EASTGATE COMMERCIAL PARK, PHASE II

FINAL DEVELOPMENT PLAN

Re: Project 611-659 Eastgate Commercial Park, Phase II – Final Development Plan

RE: Project 611-659 Eastgate Pkwy Final Development Plan

Checked By:

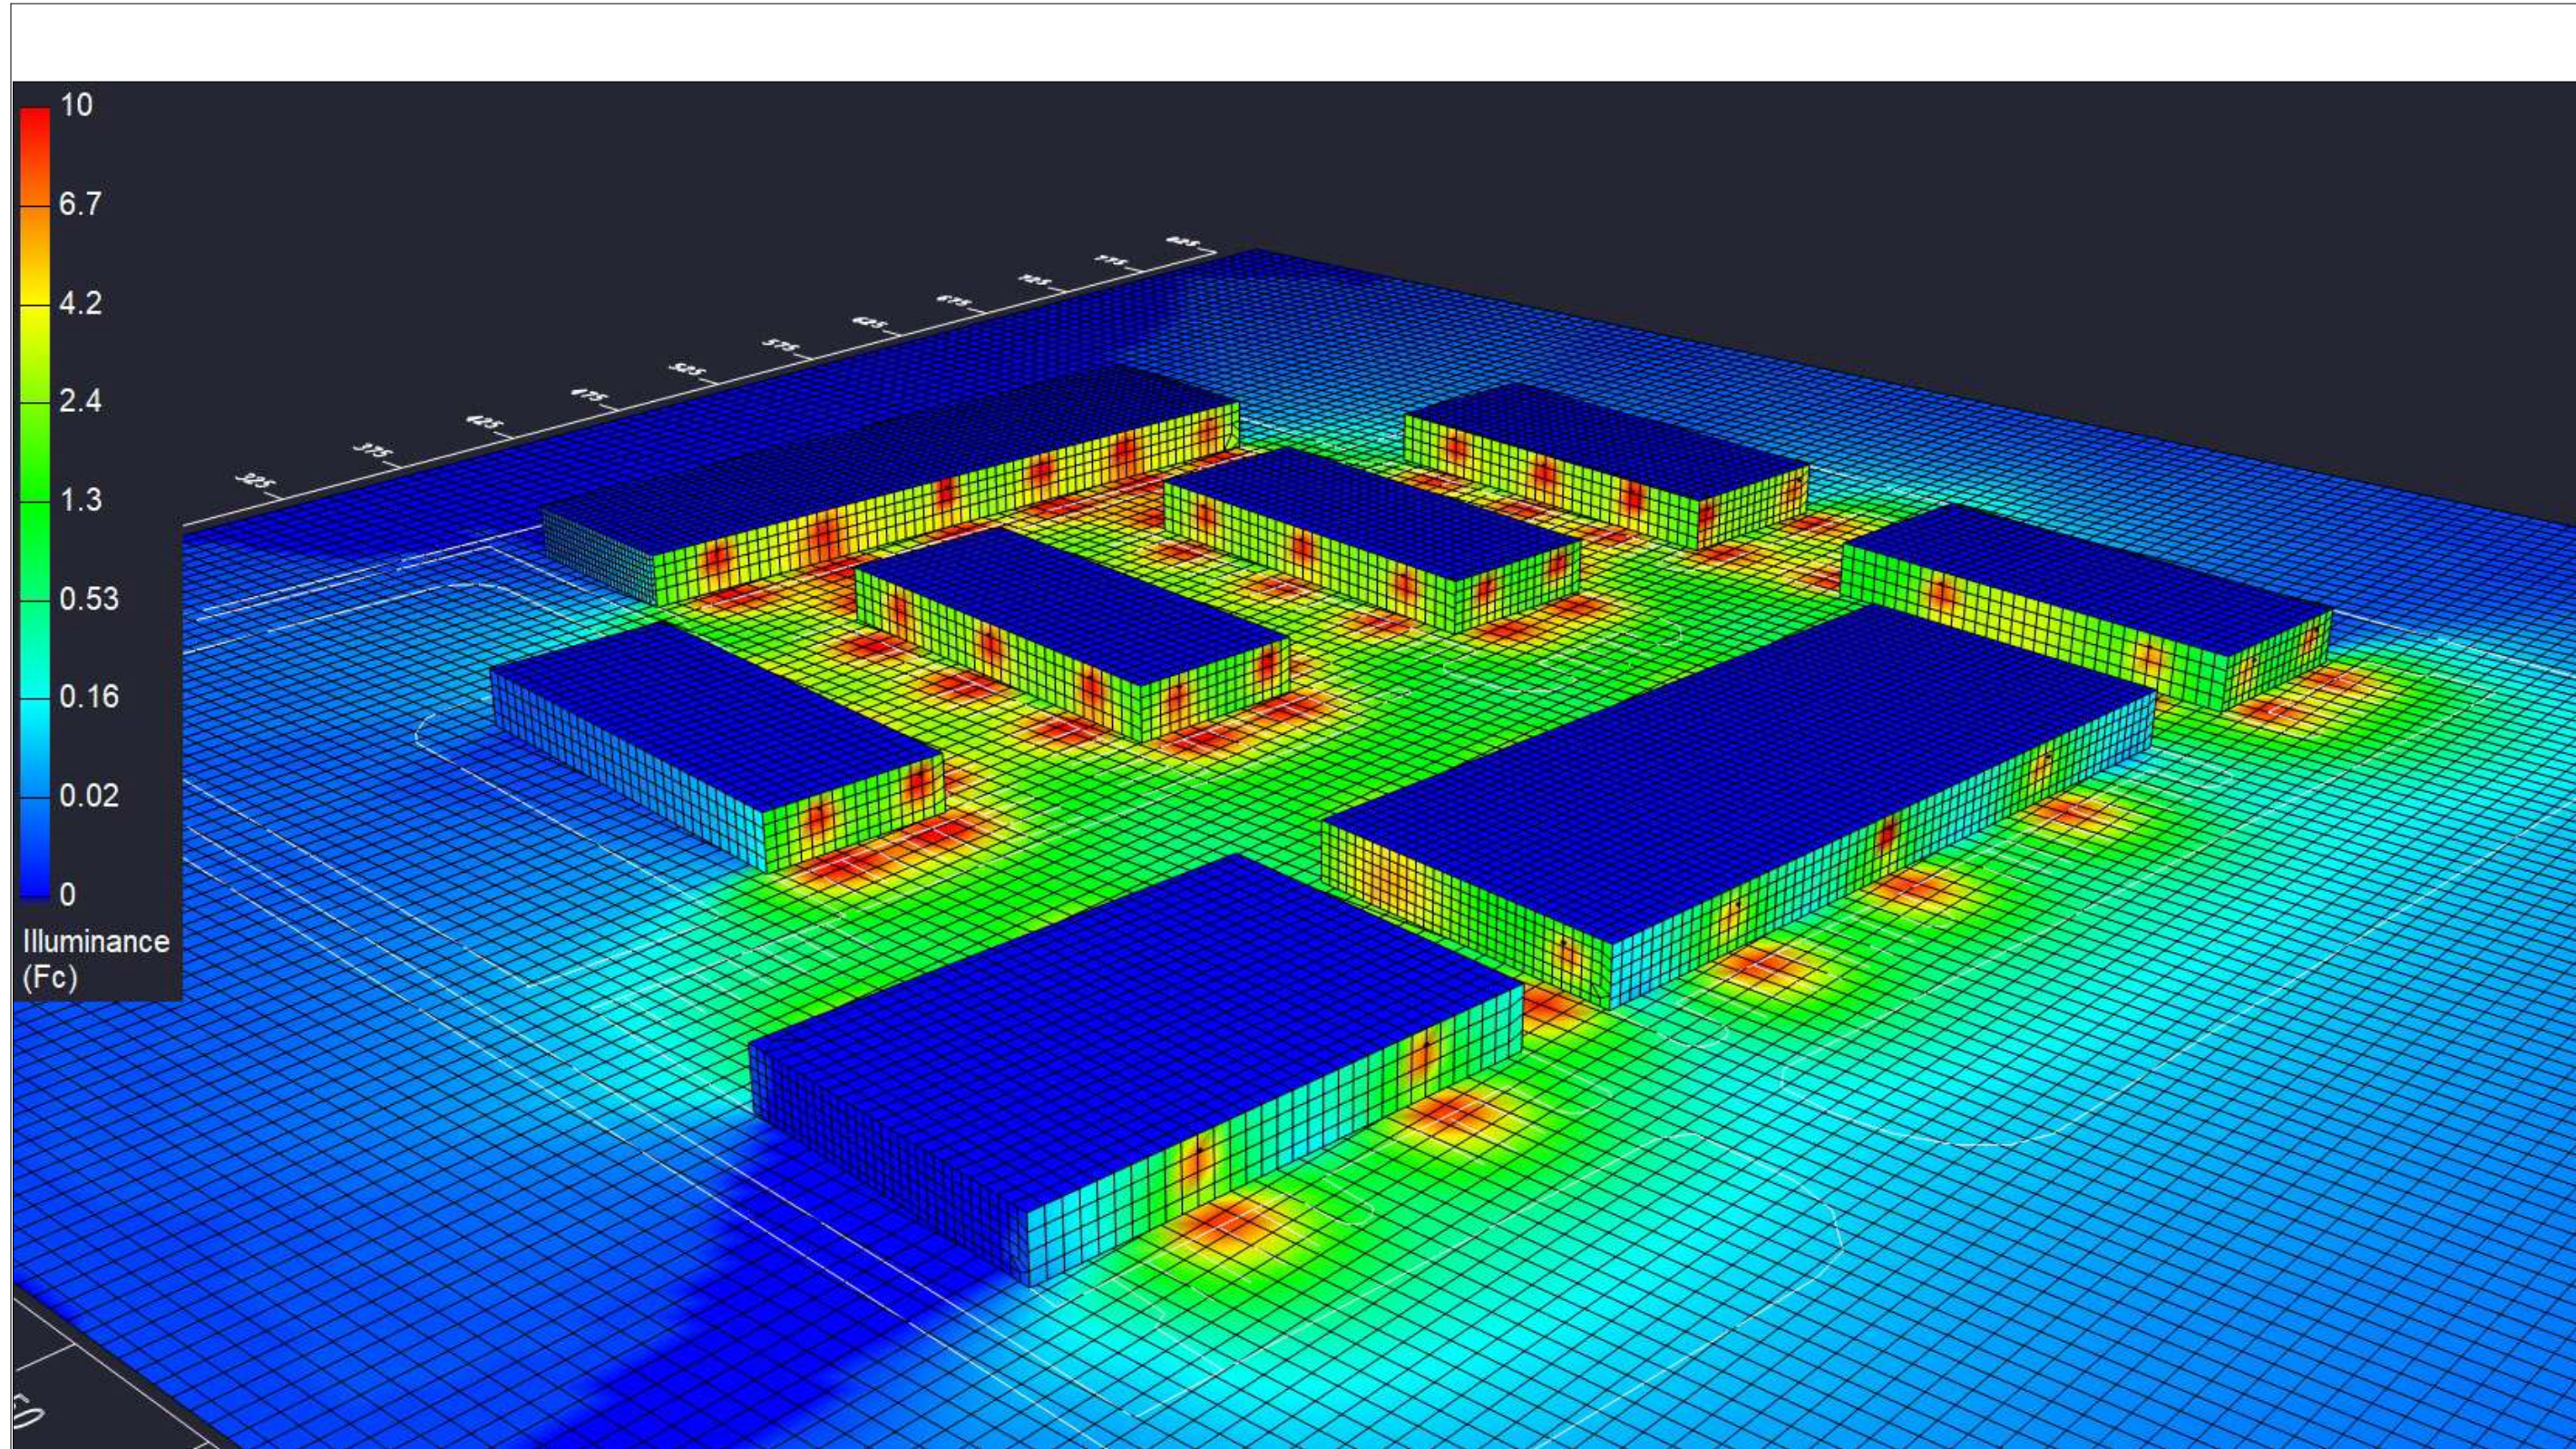
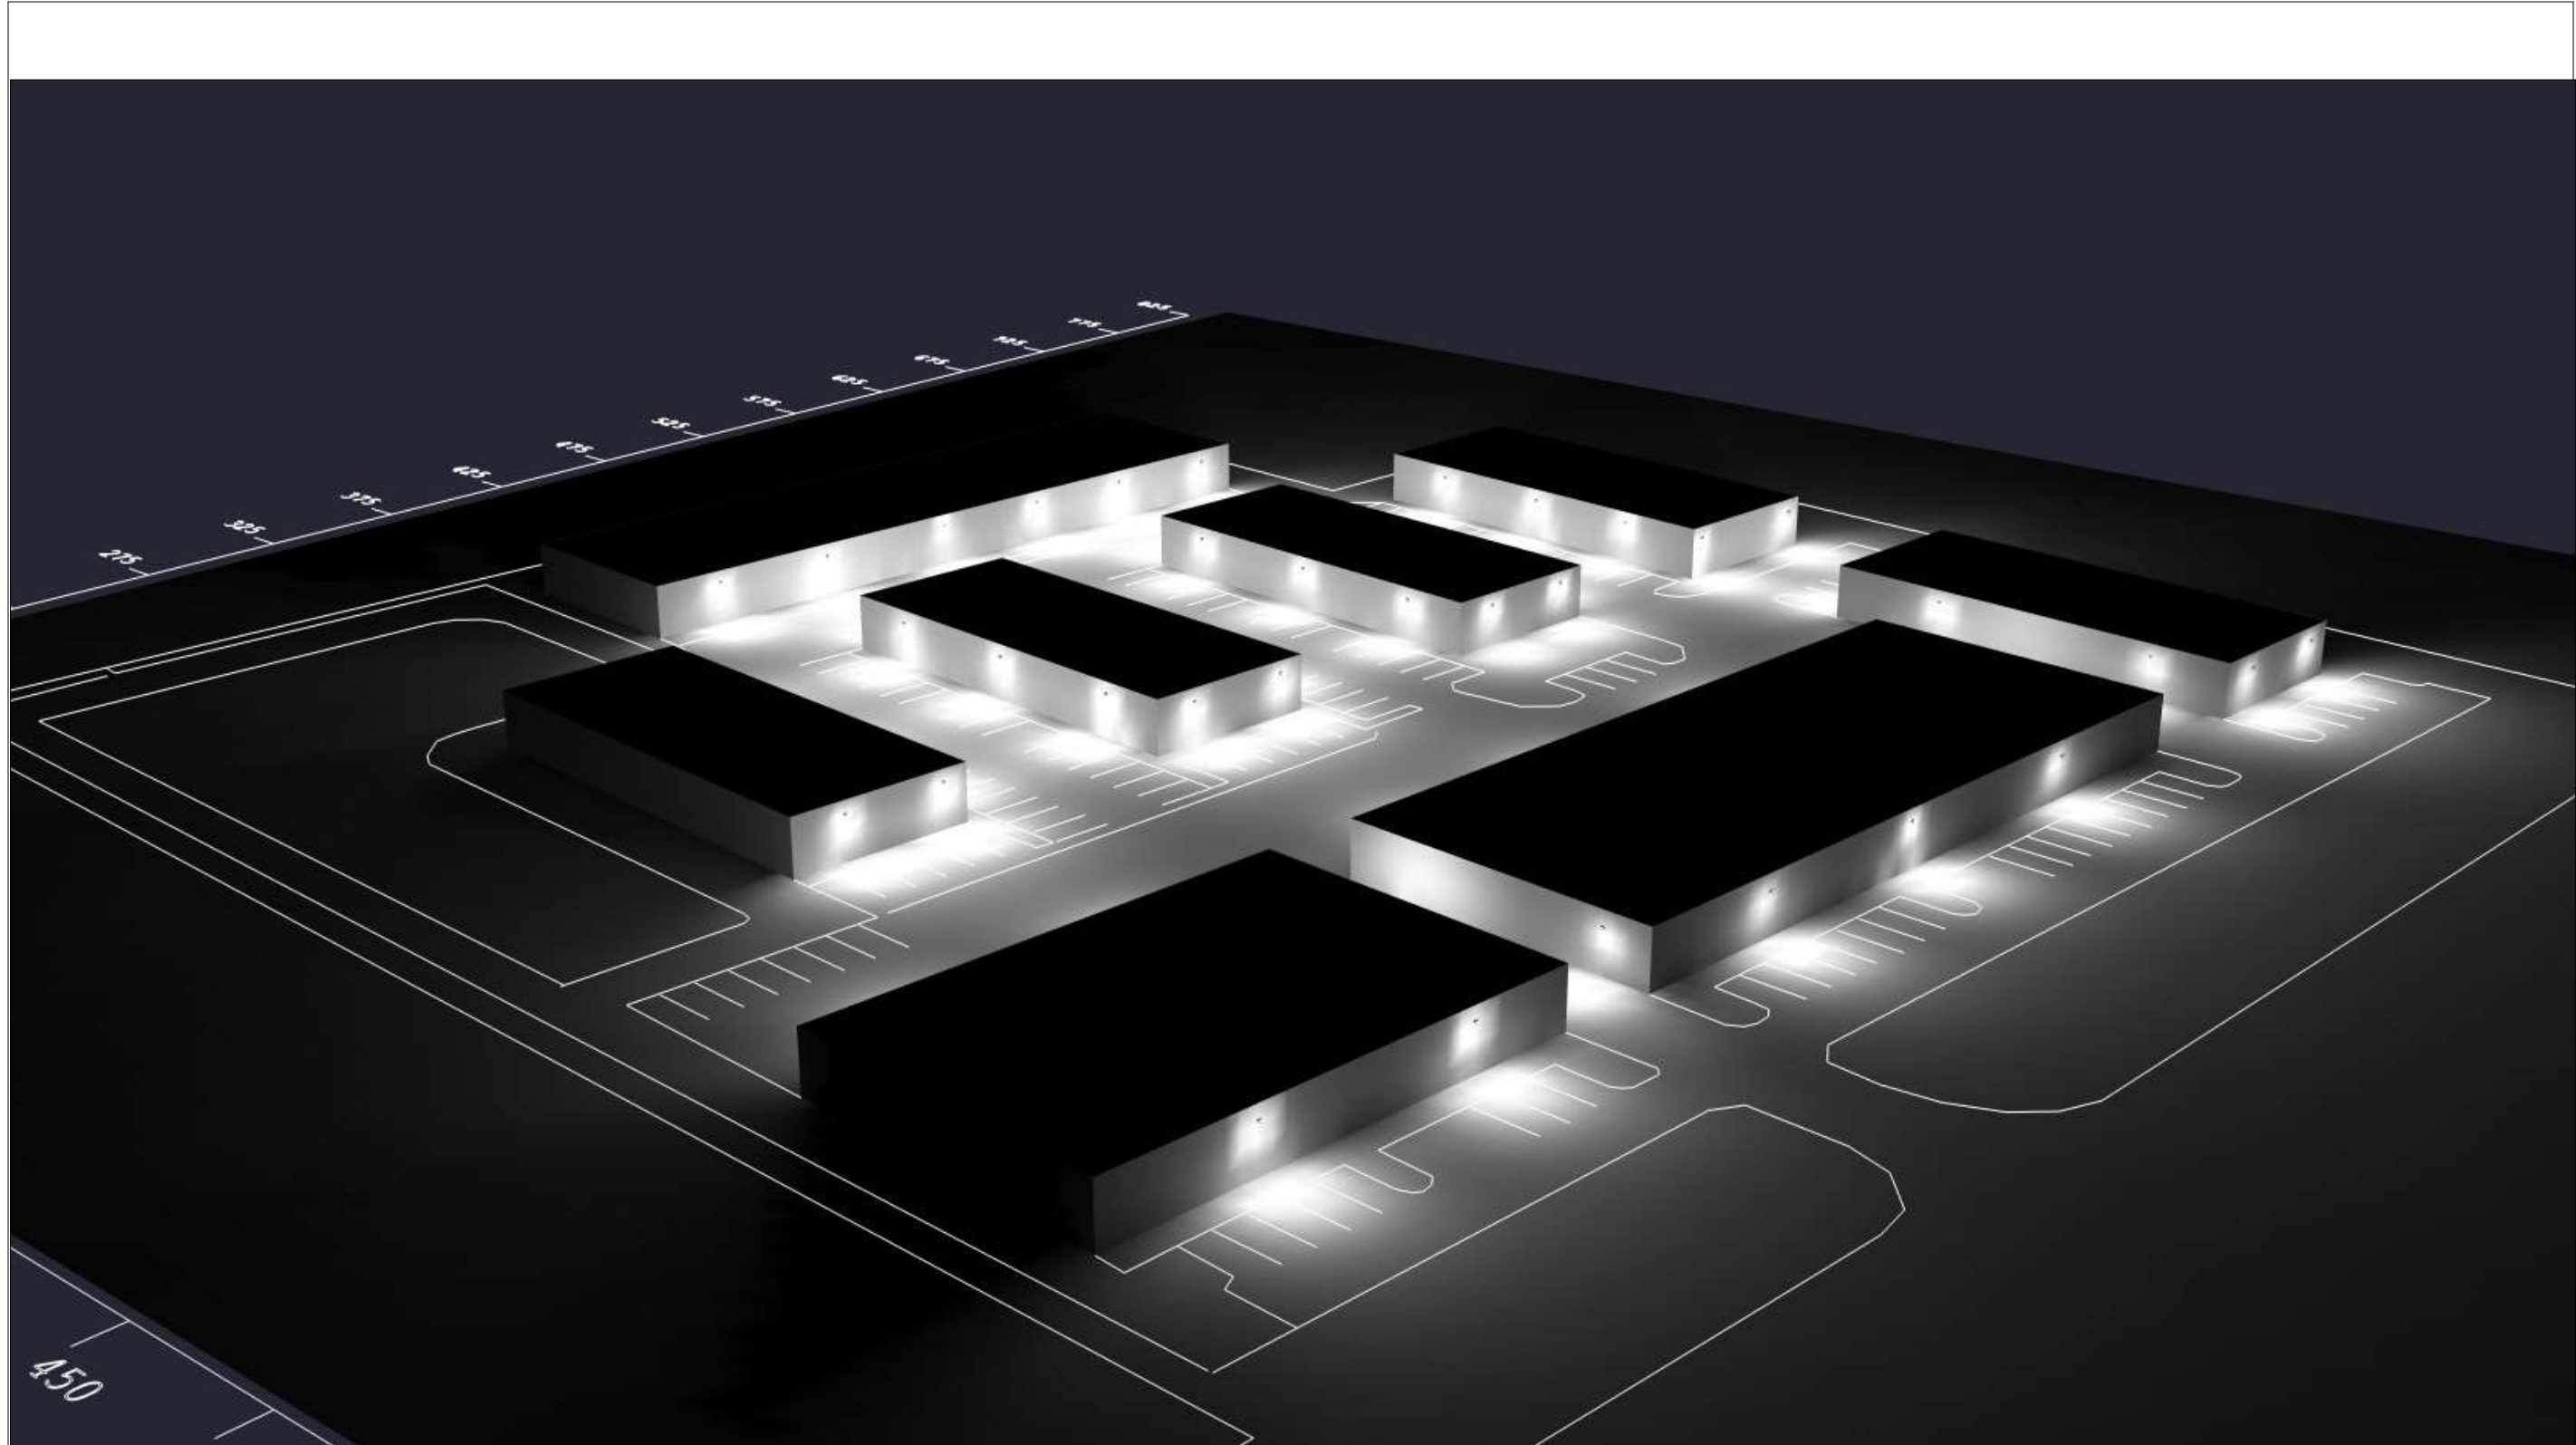
6. Label parking lot lighting as required per Section 1163.06 and 1155.08. Please note the proposed footcandles.
All proposed lighting will be wall mounted. Lighting sheet added.

4. Label parking lot lighting as required per Section 1163.06 and 1155.08. Please note the proposed footcandles. The submitted lighting plan shows the previously approved building layout - not the proposed layout with the large 18,200sqft building. Update the plan to reflect the new layout. *Updated Accordingly.*
